# Work Order ID 78575

Item Name: Crosstube Aft

DART AEROSPACE LTD		Work Order:	78575
Description: Crosstube High Aft (412)		Part Number:	D412-664-203
Inspection Dwg: D412-664-243 Rev: E		Page 1 of 1

DRAWING NO. D412-664-243	TITLE CROSSTUBE ASSEMBLY (412 HI AFT)	REV. E	DART AEROSPACE LTD ENGINEERING ORDER		D.E.O. NO. D412-664-243-E-1	SHEET NO. SHEET 1 OF 2	SCALE NTS
DRAWN	CHECKED <i>MP</i>	MFG. APPR. <i>E</i>	APPROVED <i>MP</i>	DE APPR. <i>MP</i>			
DATE 11.03.31	DATE 11/03.31	DATE 11.03.31	DATE 11/03.31	DATE 11.03.31

**D412-664-243  
ASSEMBLY DETAIL**

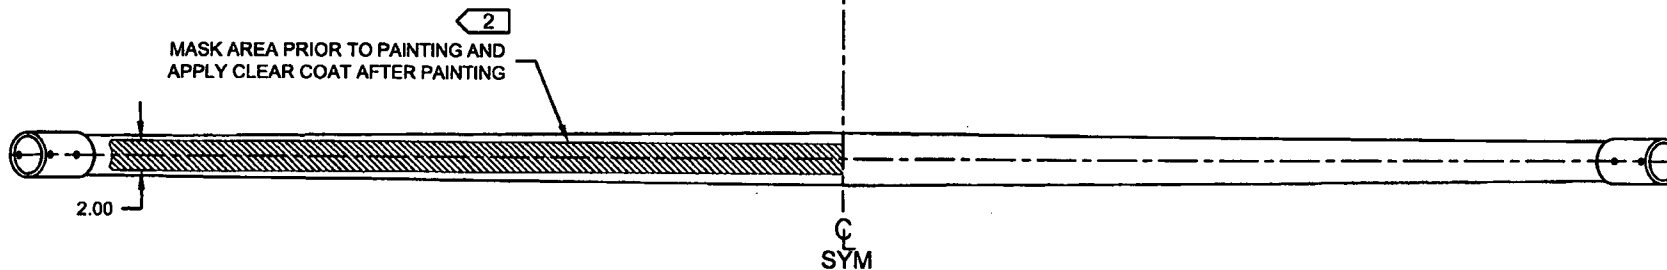
**IS:**

D3189-1 CHAFING SHIELD (1, INSTALLED OVER PROSEAL 890)  
MS21920-28 CLAMP, 2X  
2 PL

D412-664-603  
BENT TUBE

**WAS:**

D2856-600-1009 ABRASION STRIP  
D3189-1 CHAFING SHIELD (1, INSTALLED OVER ABRASION STRIP)  
MS21920-28 CLAMP, 2X  
2 PL

CRUSHING OF 1942-664-243

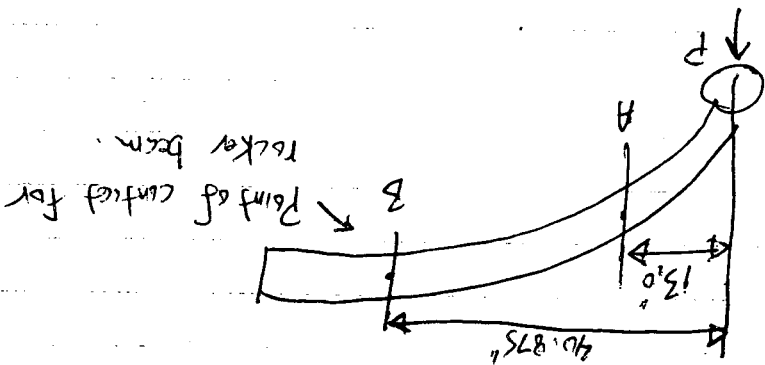
Acceptability of 8% CRUSHING AT END OF BEND

Point A:  $OD_1 = 2.961$ ,  $OD_2 = 2.522$

CRUSHING =  $(2.961 - 2.522) / (2.961 + 2.522) = 8\%$   
 $I = 1.676 \text{ in}^4$  (from AutoCAD)  
 Point B:  $OD_1 = 3.307$ ,  $I = 4.613 \text{ in}^4$

A:  $F = Mc/I = P \times 13 \times 2.961 / 2 \times 1.676 = 11.484 \times P$   
 B:  $= P \times 40.875 \times 3.307 / 2 \times 4.613 = 14.651 \times P$

M.S. =  $14.651 / 11.484 - 1 = 0.27$
